STATE OF WASHINGTON
DEPARTMENT OF ECOLOGY
7272 Cleanwater Lane, LU 11 • Olympia, Washington 98504 • (206) 753-2353

MEMORANDUM
October 25, 1982

Subject: Renton Treatment Plant, Water Quality Issues: Response to PSCOG Working Paper

Figure 2. Dissolved oxygen profile, Green/Duwamish River.

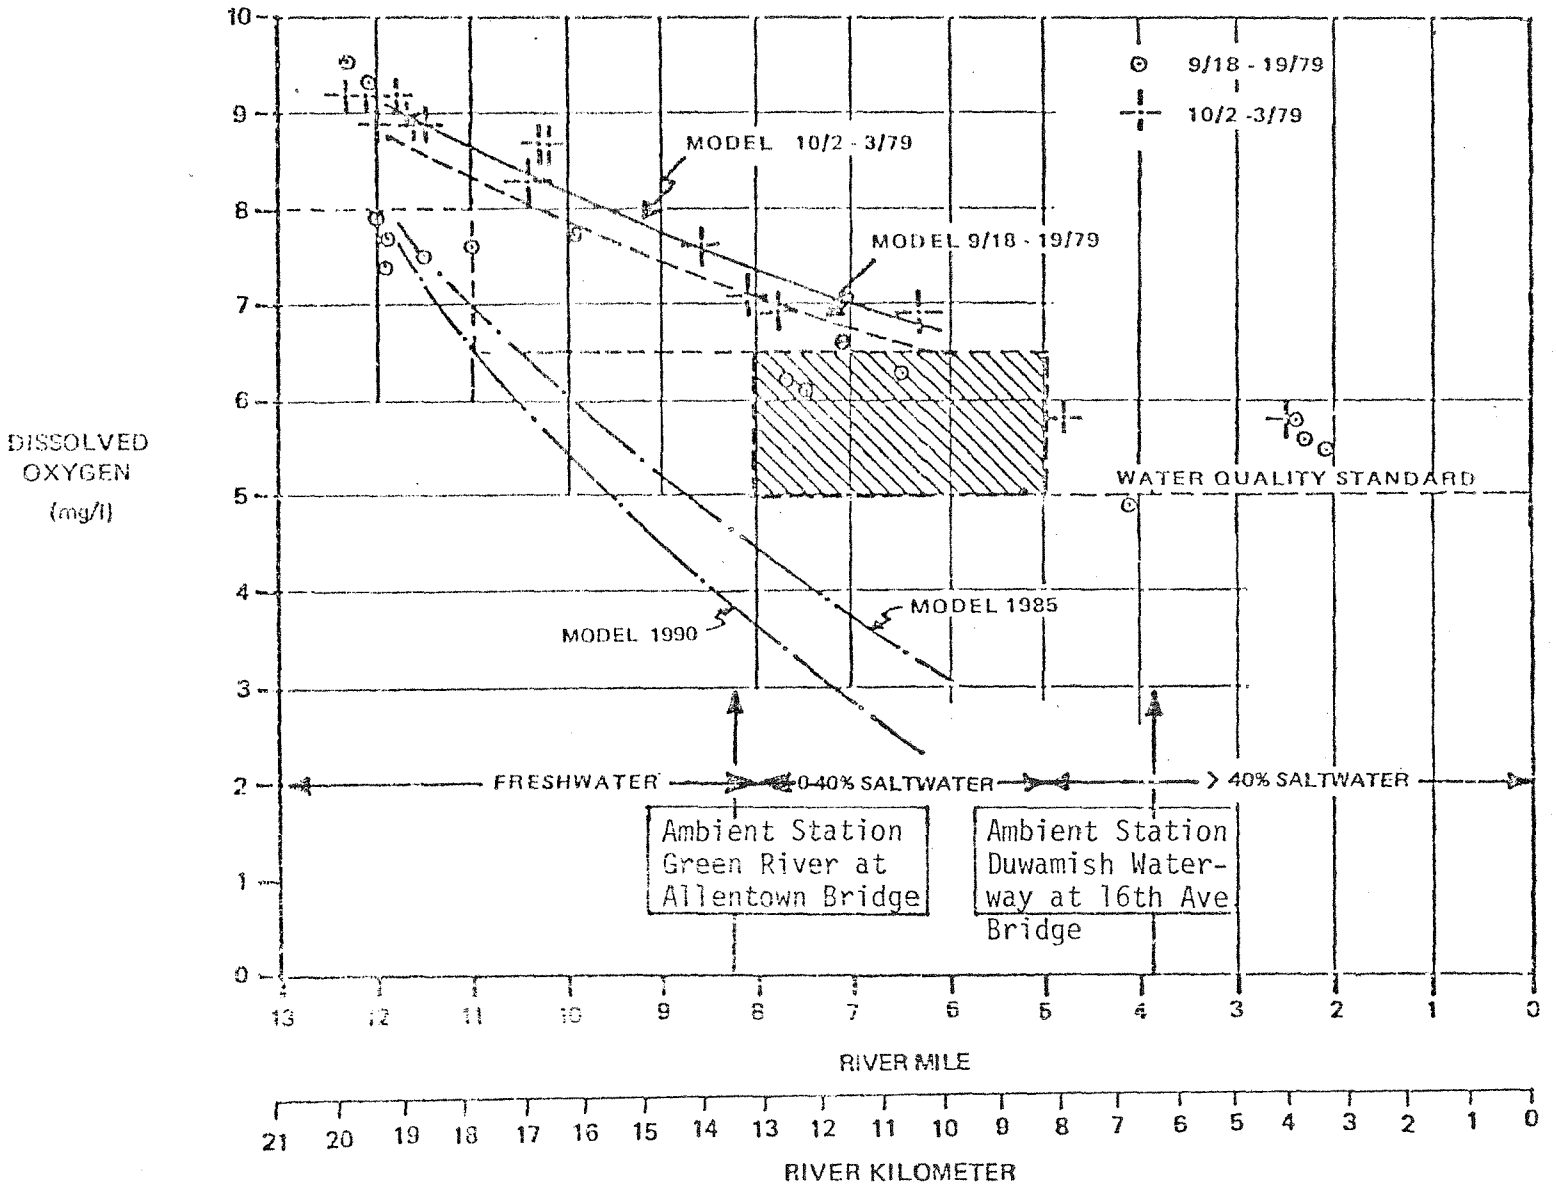
The primary cause of D.O. depletion in the lower Green/Duwamish River and in surface waters of the dredged waterway is ammonia discharged from the Renton plant. Low D.O. concentrations in the Renton effluent contribute to D.O. standards violations near the discharge. All available information suggests that as ammonia loads from the plant increase, downstream and waterway surface D.O.s will be further depressed.

Response: Misleading analysis. The winter-to-summer decrease of "13 mg/L to 6.5 mg/L" is largely a natural,

physical phenomenon related to water's ability to hold dissolved oxygen at various temperatures. A preferable analysis would look at percent saturation values upstream and downstream of the plant. Table I does this. Based on Table I, Renton is responsible for about 64% of the observed depletion on an annual basis, and about 74% of the depletion observed in the July-to-October period.
